Design Revisions Item #10 - Tie To Low Rise Neighbors

Pre-ANC Feedback

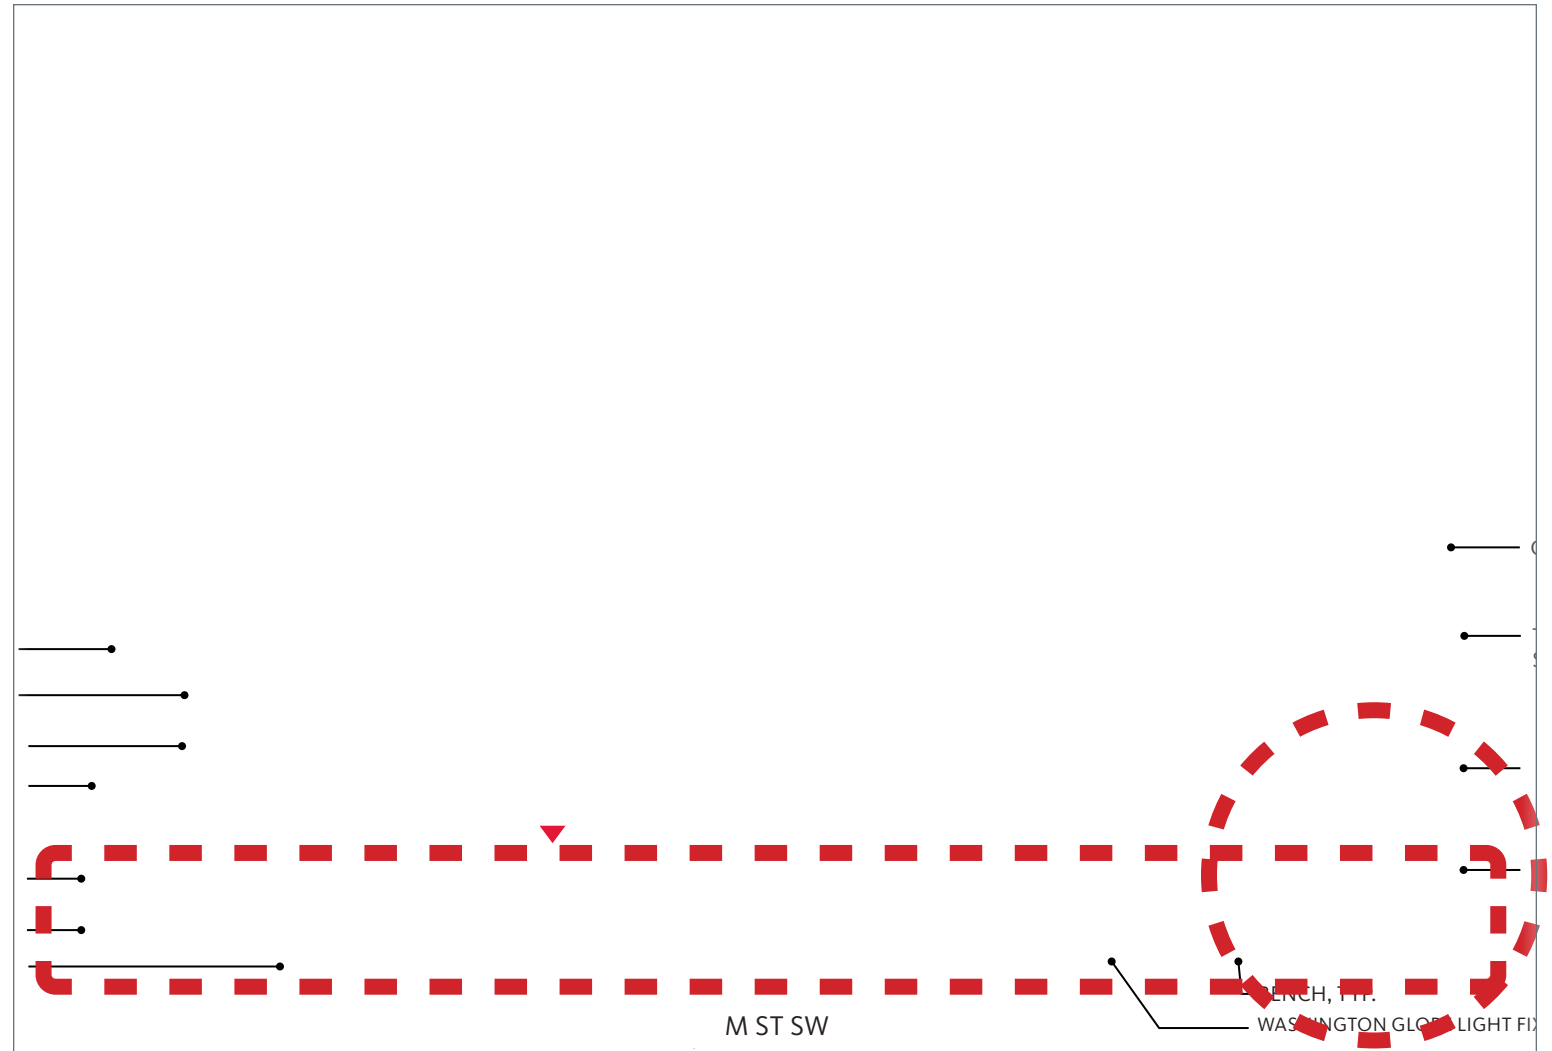
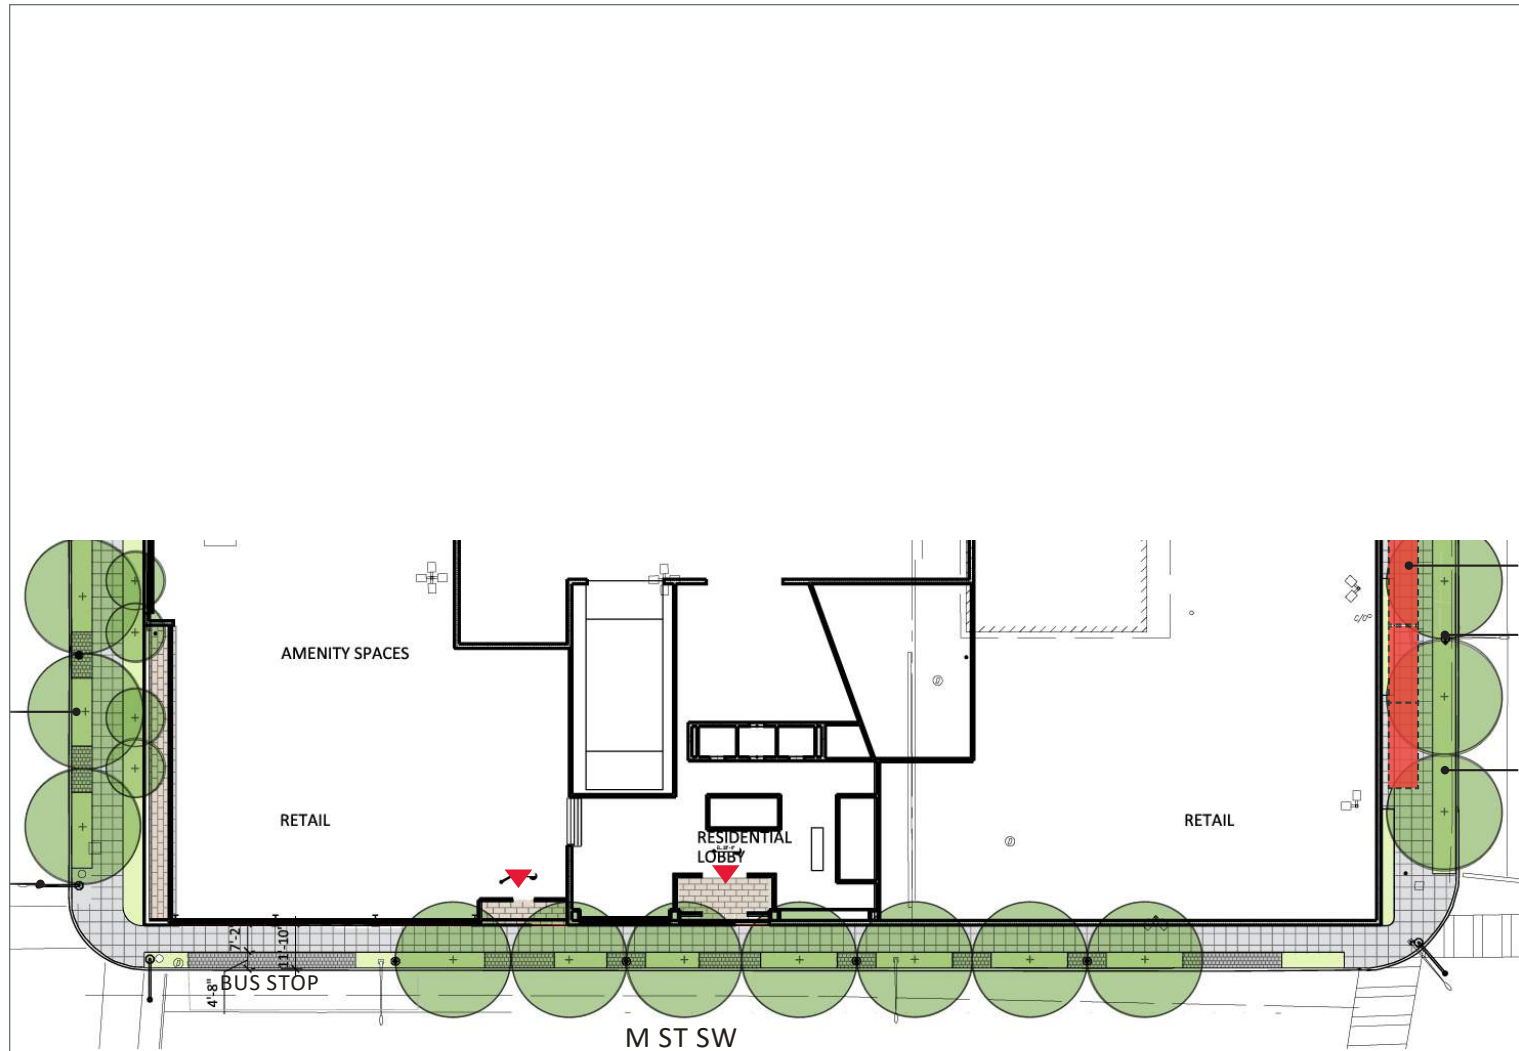
- Added a reveal at level 3 to better highlight a pedestrian-centric scale of the walk-up units.
- New reveal better associates the podium with low-rise neighbors.

Design Revisions Item #12 - Set Back Facade on M Street

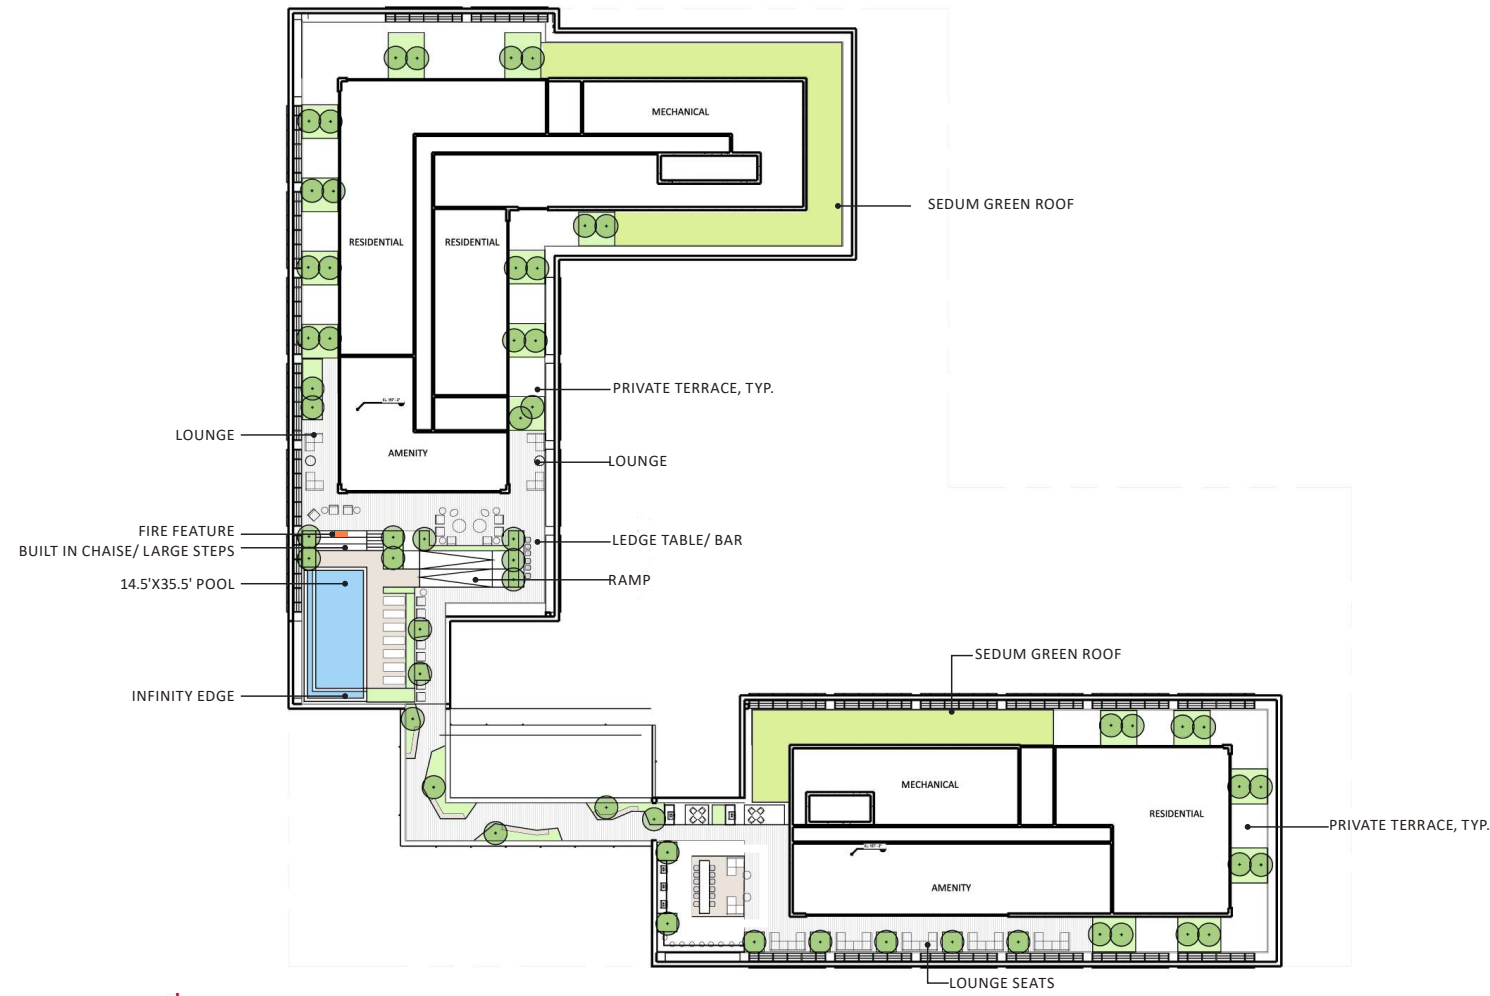
- Added setback at levels 12 & 13 that aligns with upper pavilion setback (10'-0").

Design Revisions Item #13 - Dog Relief Zone

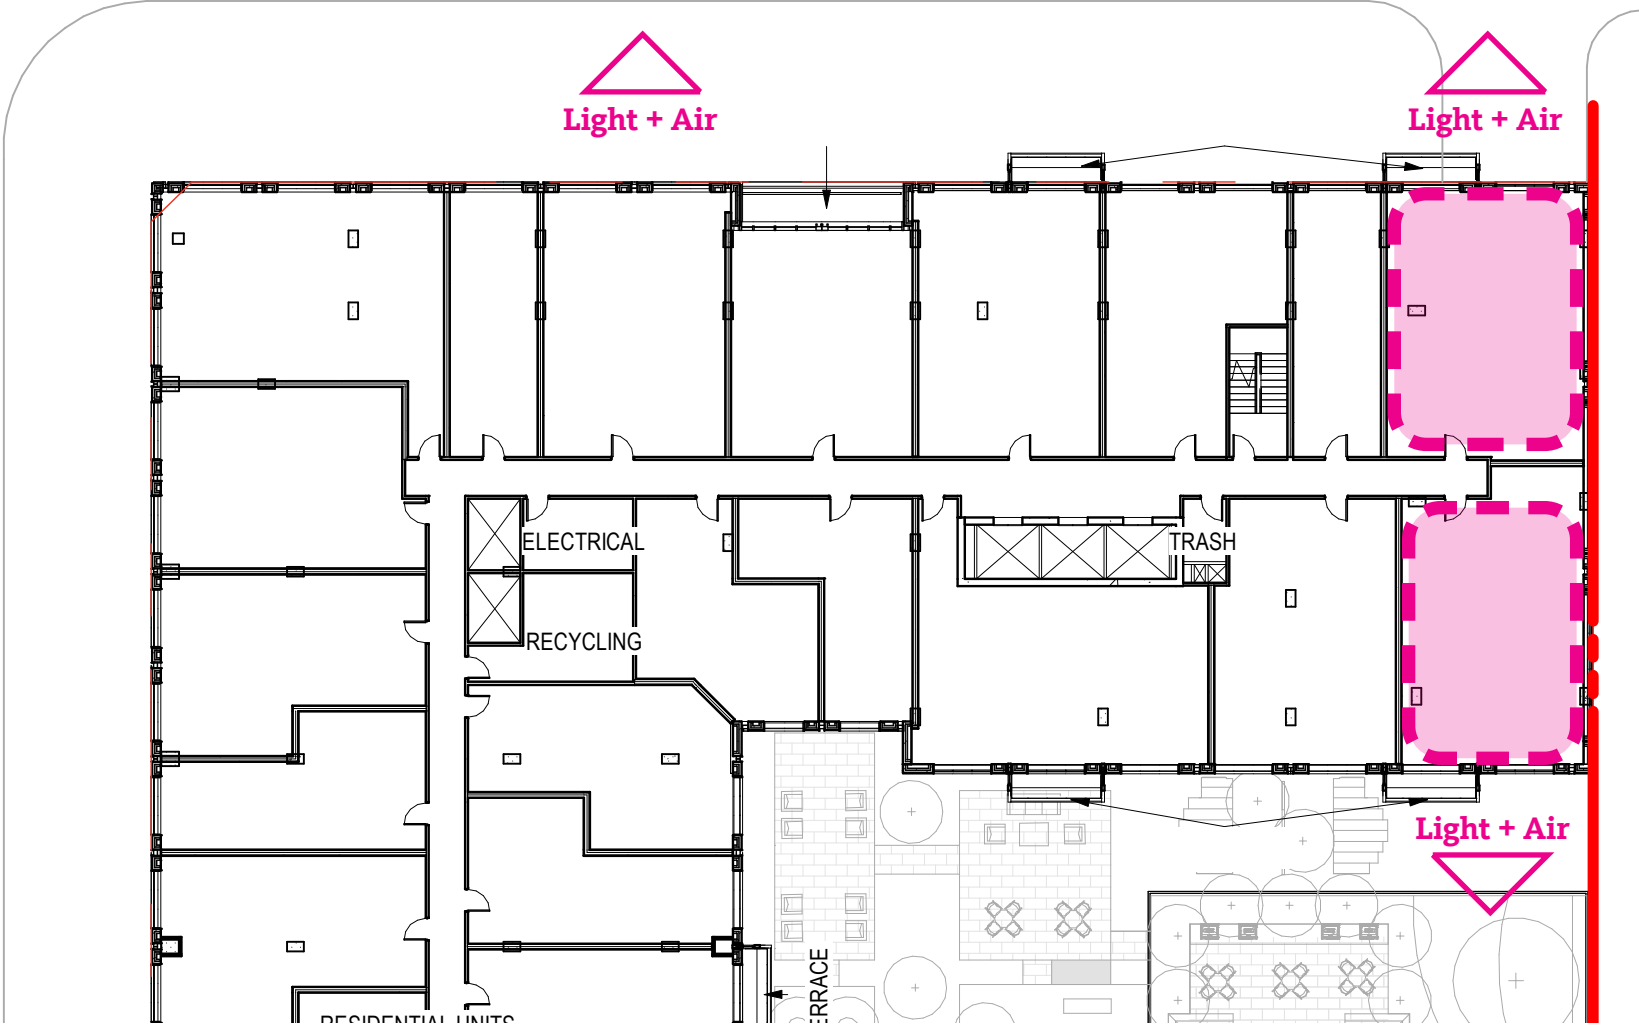
- Added dog relief zone.
